# DUKE POWER COMPANY

Re: Catawba Nuclear Station  
Docket Nos. 50-413 and 50-414

In order to facilitate the completion of the review of the Catawba FSAR, Duke Power Company is transmitting herewith responses, revised responses, or partial responses to the following FSAR questions:

SPENT FUEL POOL  
TEMPERATURE VERSUS TIME  
CATAWBA NUCLEAR STATION  
Figure Q410.12-1

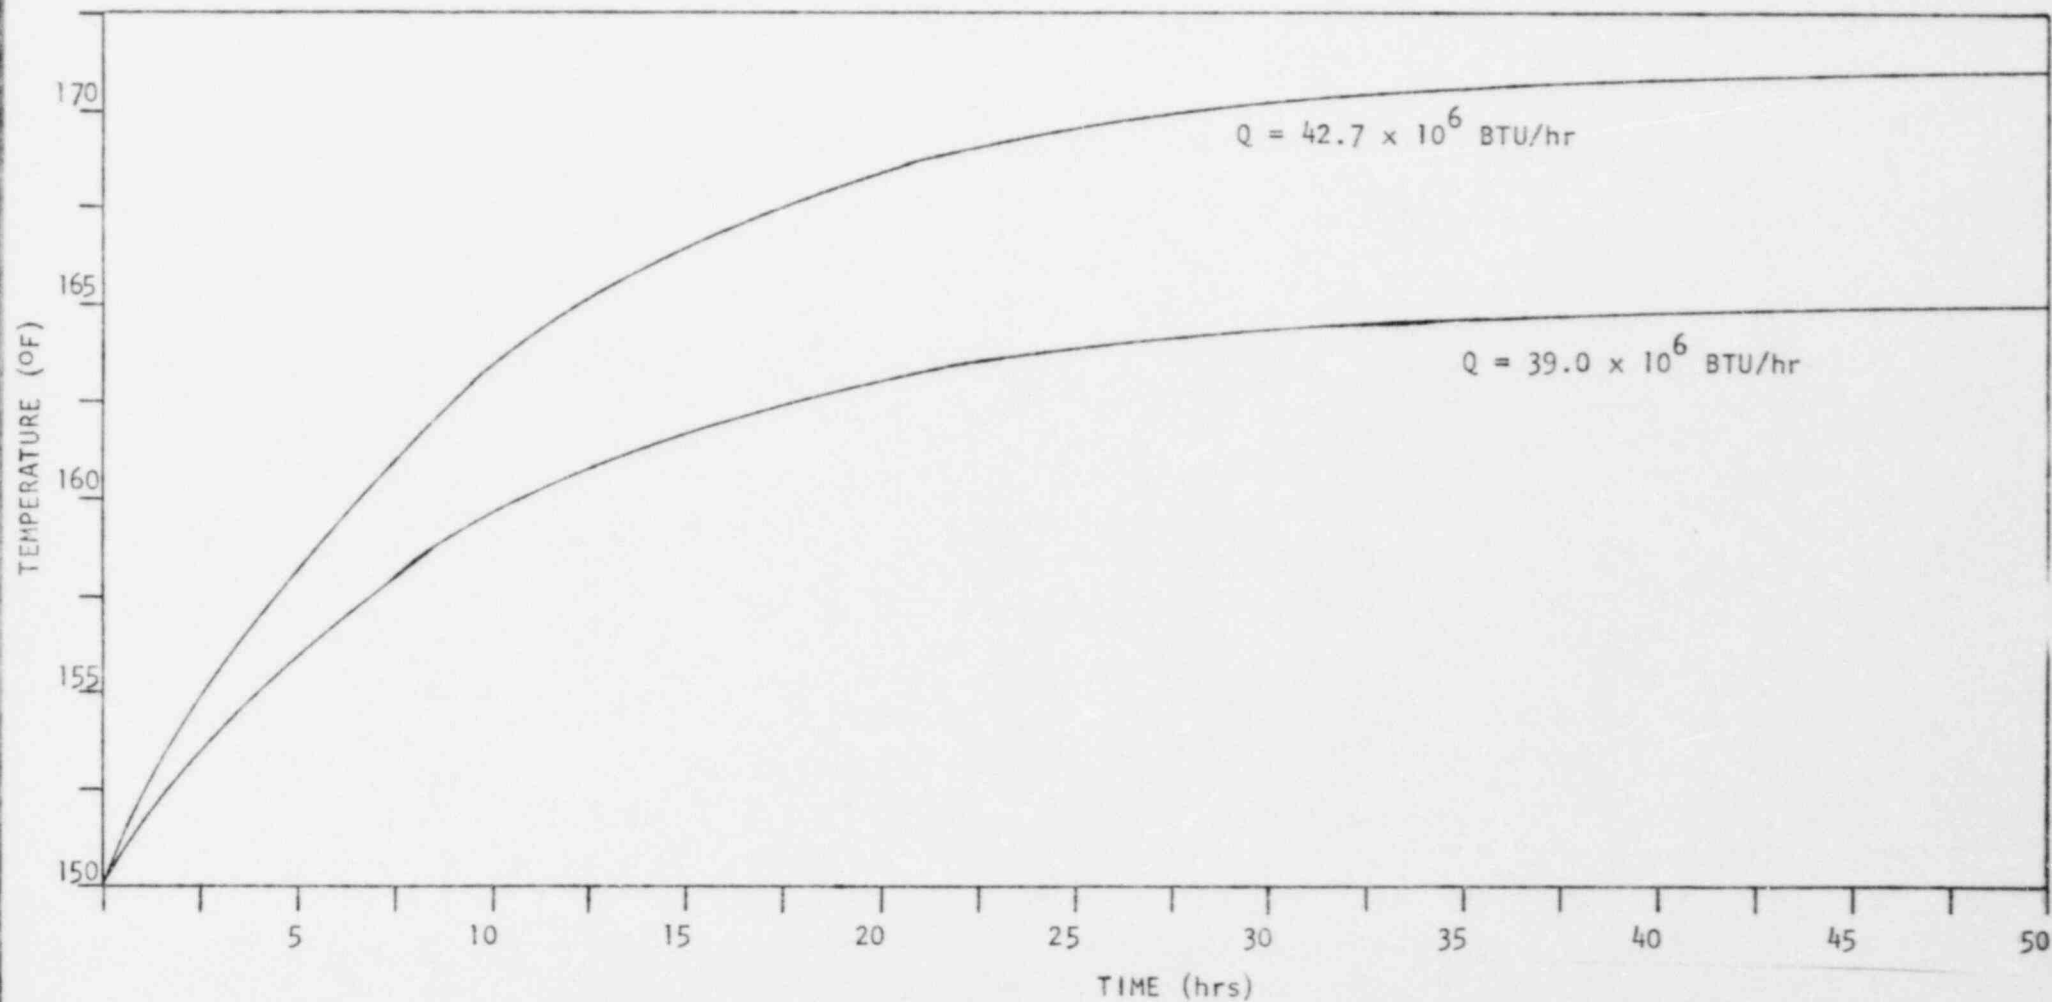
Provide information on the spent fuel pool water temperature following the loss of one cooling train assuming the maximum heat load condition with Catawba fuel and with non-Catawba fuel. Present an analysis of temperature vs. time for these two conditions. Describe

the disposition of the heat load to all heat sinks including the spent fuel pool heat exchanger, the spent fuel pool water purification system, any waste or drains, and the environment of the fuel building. Discuss the effects of the heat and humidity load on the fuel building ventilation system.

An analysis of temperature versus time for  $Q = 39.0 \times 10^6$  BTU/hr (Catawba fuel) and  $Q = 42.7 \times 10^6$  BTU/hr (non-Catawba fuel) was performed using only one spent fuel pool heat exchanger and the pool water as heat sinks. The results of this analysis are presented in Figure Q410.12-1.

The additional heat and humidity load for these two cases would not affect the fuel building ventilation system.
